Product Change Notification

PCN-TT-4948-2020

Description for Product Change Notification

Previous Product	New Product
<p>VC 02</p>  <p>VC 03</p> 	<p>VC 04</p>

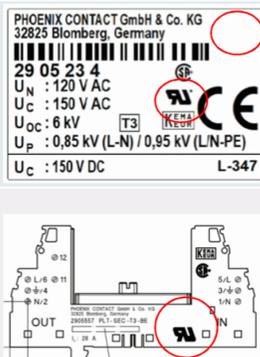
The "c UR us" Recognition MARK was deleted and replaced by a UR Recognition MARK on PLT-SEC-T3 Plug / Base combination products featuring Version Code (V/C) 3 and 4 identifiers.
